Environmental review team report

EASTERN CONNECTICUT
RESOURCE CONSERVATION AND DEVELOPMENT PROJECT

ENVIRONMENTAL REVIEW TEAM REPORT
ON
INDIAN RIVER WOODS SUBDIVISION
AND
PEAT REMOVAL OPERATION
KILLINGWORTH, CONNECTICUT
AUGUST, 1976

TOPOGRAPHY AND SITE PLAN

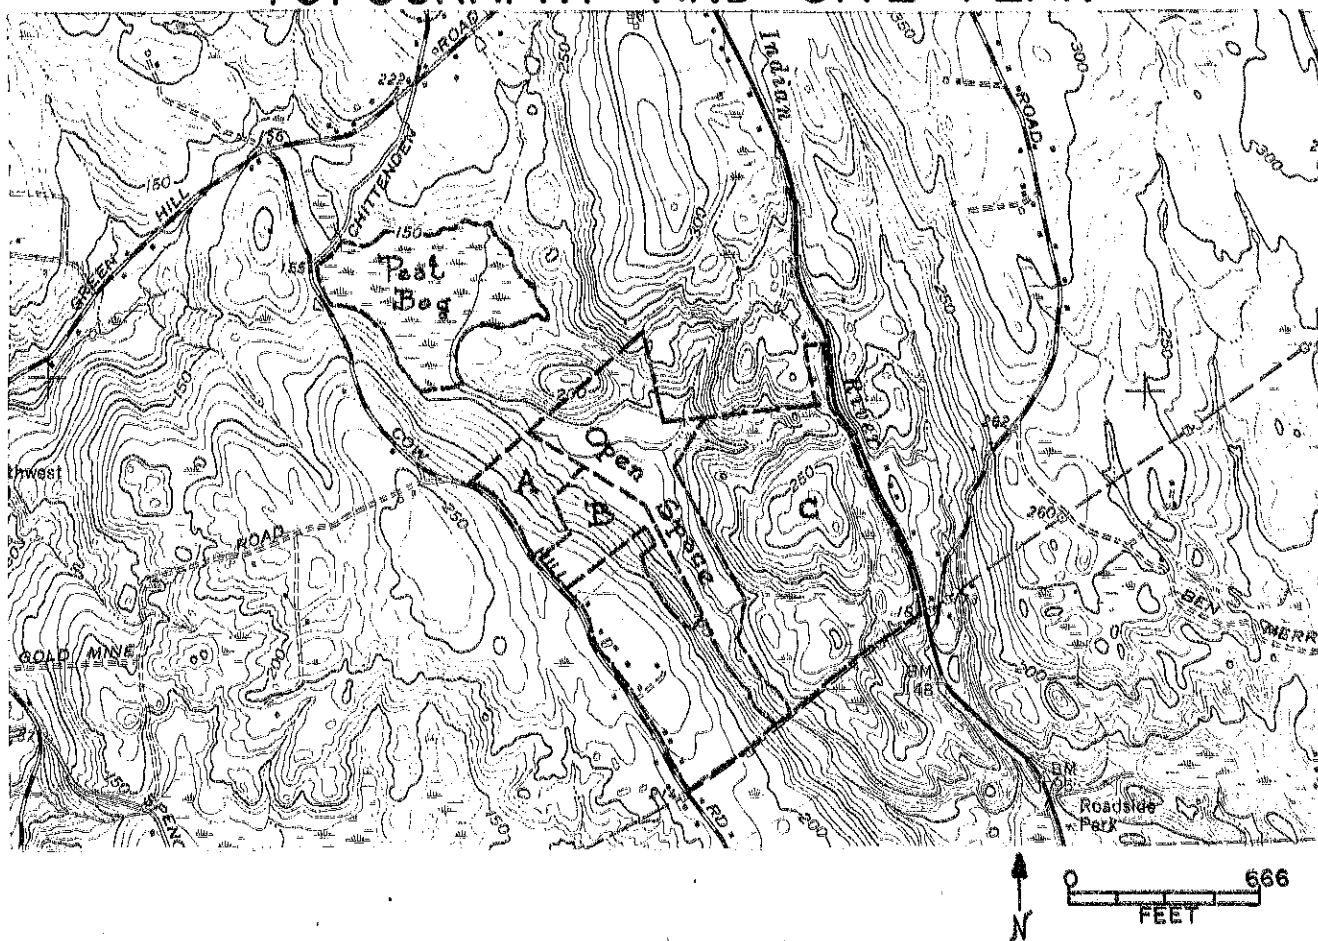
Subsurface elevations change from 135 feet above mean sea level in the valley floodplain to several hill knobs approximately 270 feet above mean sea level adjacent to Route 81. Along Cow Hill Road, land elevations reach a level of 225 feet above mean sea level. (See Topography and Site Plan map.)

plans. The proposed open space area, as indicated on the Site Plan map, will help protect the stream quality of the unnamed tributary to the Indian River, while maintaining a linear corridor for wildlife movement.

As shown earlier on the Topography and Site Plan map, a peat removal operation is proposed in an approximate 55 acre swamp consisting of both shallow and deep peat deposits. Topographically the drainage area of the swamp being considered for organic material removal consists of steep hillsides with slopes greater than 10 percent to flat or gently rounded hilltops. Land elevation changes from 150 feet above mean sea level at the margin of the swamp to 320 feet above mean sea level to the west, 350 feet above MSL to the north and 250 feet above MSL to the southwest.

SURFICIAL GEOLOGY

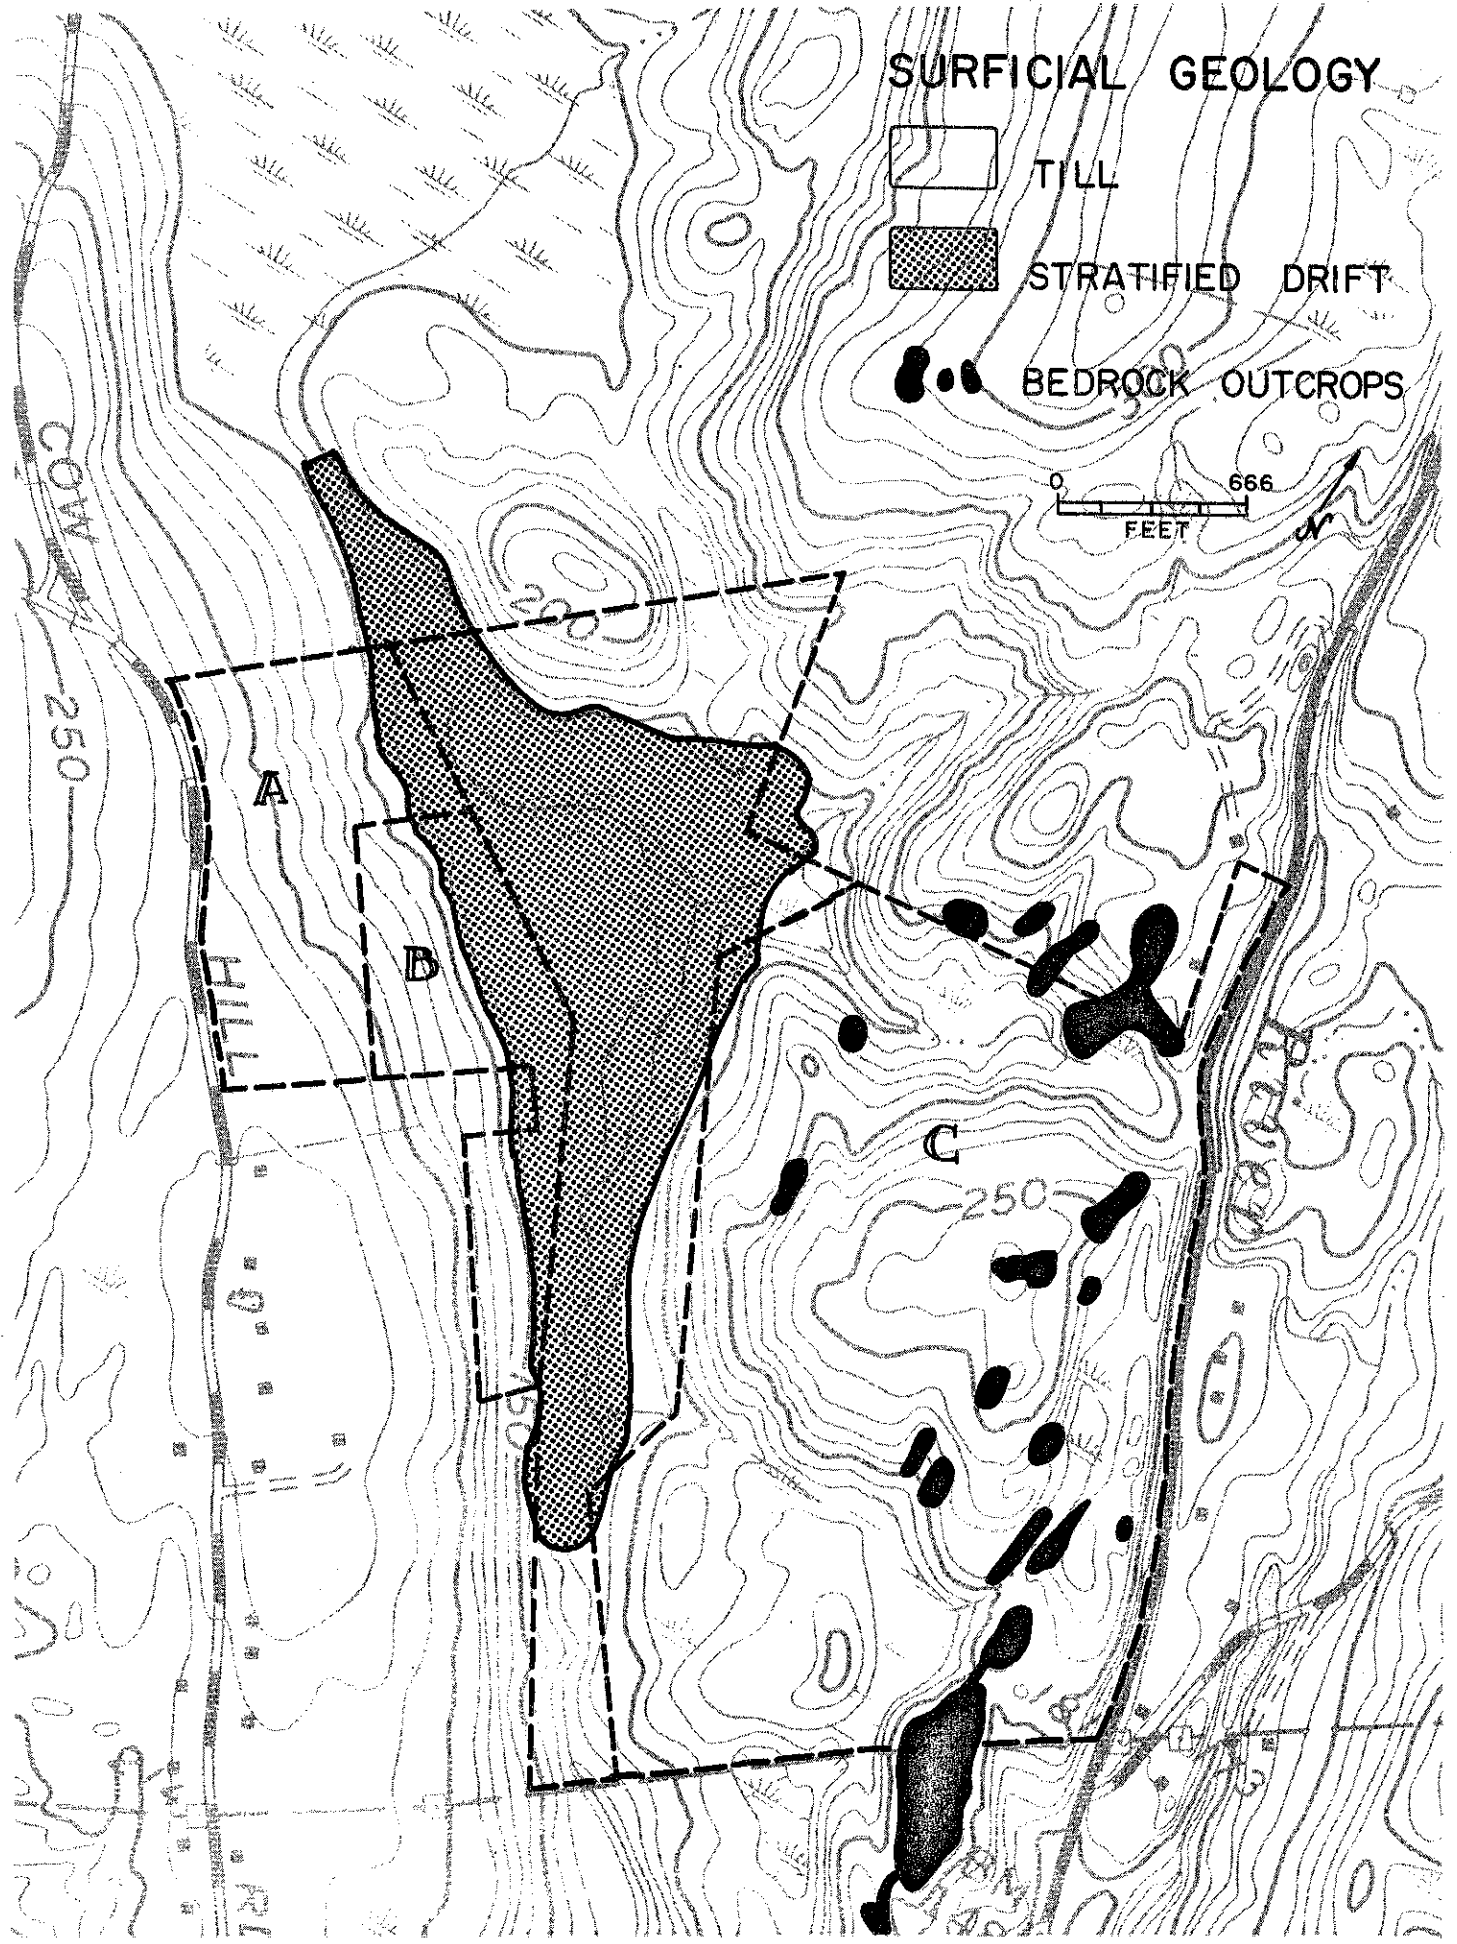
Two types of unconsolidated materials are found on the site that roughly correspond to the proposed activities for the property. Within development sections A, B and C, the primary overburden lying on top of the solid bedrock is glacial till. Within the proposed open space zone stratified drift or floodplain materials are the predominant overburden (see Surficial Geology map.) Till is the most widely distributed overburden material found in the state and was formed from rock and soil particles that were picked up and carried on, within or under glacial ice in the past. Once the ice melted, what remained in place is known as "glacial till." Till is a heterogeneous material composed of various mixtures of boulders, gravel, sand, silt and clay particles, none of which are significantly sorted or stratified according to grain size. Till deposits are normally found on hillsides and hilltops.

The thickness of overburden material is an important factor of consideration, particularly as it pertains to siting and designing of foundations and on-site septic systems. Development sections A and B along the western valley wall contain a thicker till section than is found on the sides and hilltops of the C section to the east.

In general, it may be said development sections A and B have overburden thicknesses greater than 10 feet to bedrock and probably the average thickness exceeds 20 feet. The Surficial Geology map showed that the greatest concentrations of bedrock outcroppings occurred in section C, indicating a relative shallow till over-

SOIL MAP

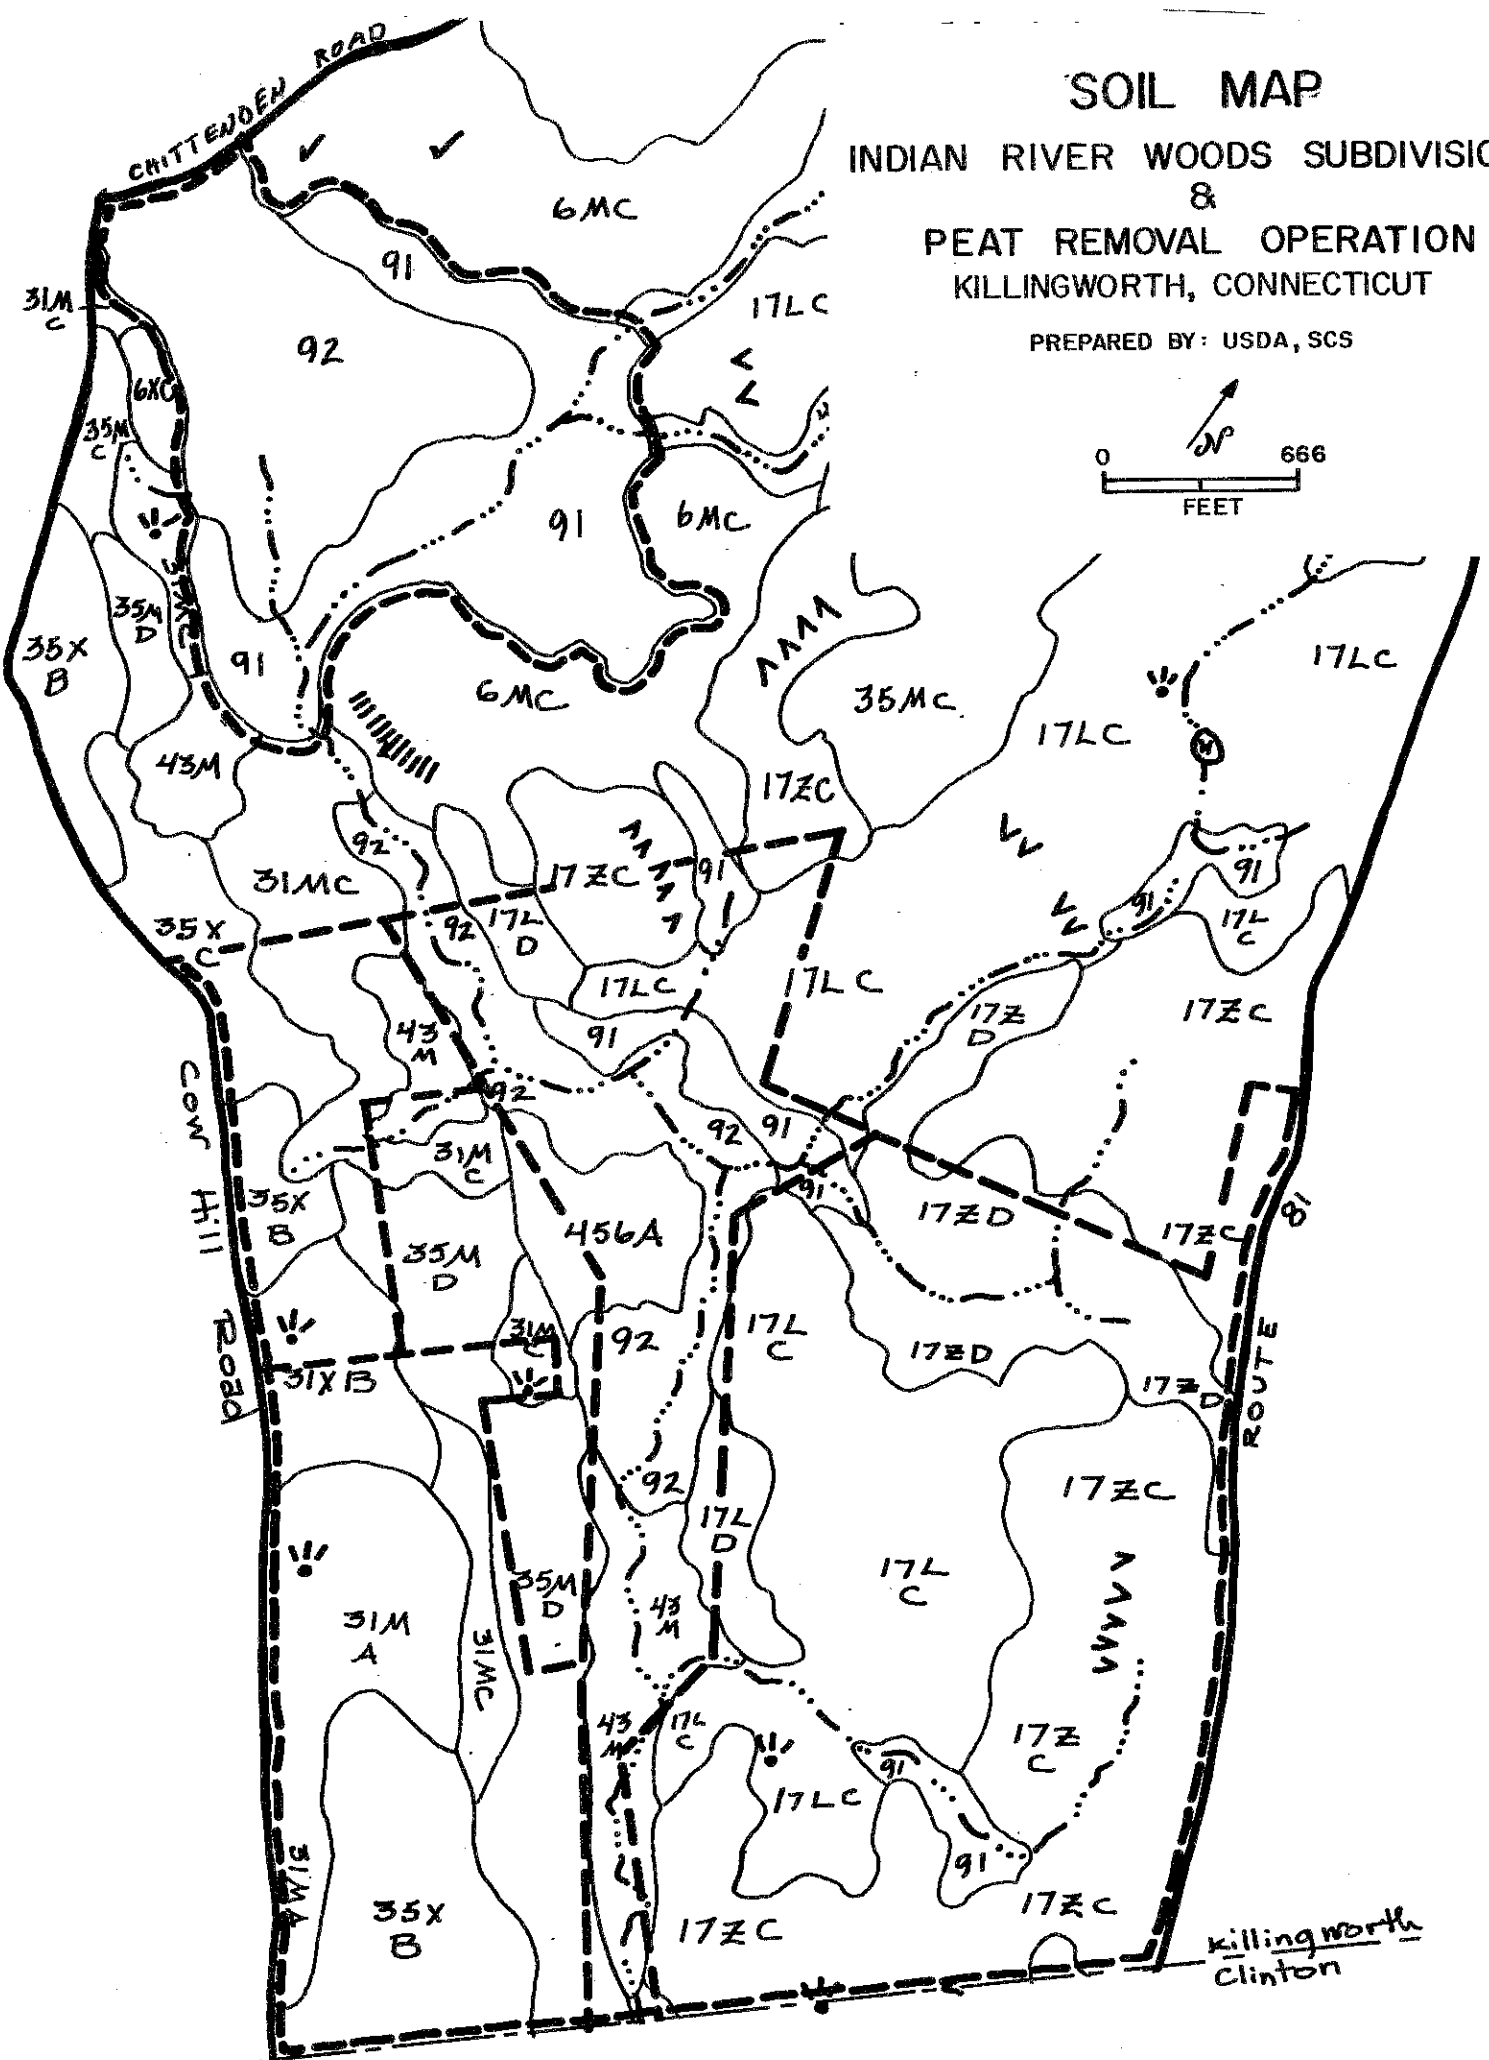
A detailed soil map of the site is given in the Appendix of this report. As the soil map is an enlargement from the original 1,320'/inch to 660'/inch scale, the soil boundary lines shown should not be viewed as absolute boundaries but rather as guidelines to the distribution of soil types on the property. The soils map, along with the SPECIAL SOILS REPORT, Middlesex County (USDA, SCS, 1975), can serve as an educational tool regarding the identification and interpretation of soils.

As indicated on the soils map found in the Appendix of this report, the swamp is composed of 91 and 92 soils. 91 is an Adrian and Palms Muck soil. These are deposits of plant remains ranging from 16 to 50 inches in depth and occurring in very poorly drained areas. They are remains of reeds, sedges, sphagnum moss, trees, and shrubs which grow in wet areas. All such deposits have high organic matter content but some are mixed with sand, silt, and clay. The underlying mineral layers are sandy or loamy. The 92 soil is a Carlisle muck which are deposits of plant remains more than 51 inches thick. They formed chiefly in woody organic deposits but may include remains of reeds, sedges, sphagnum moss and shrubs which grew in wet areas. From the soil map there appears to be approximately 28 acres of 91 soil, and 27 acres of 92 soil. On-site test borings are necessary to determine the exact acreage and more importantly, the actual depth of the peat deposits, and hence expected yield.
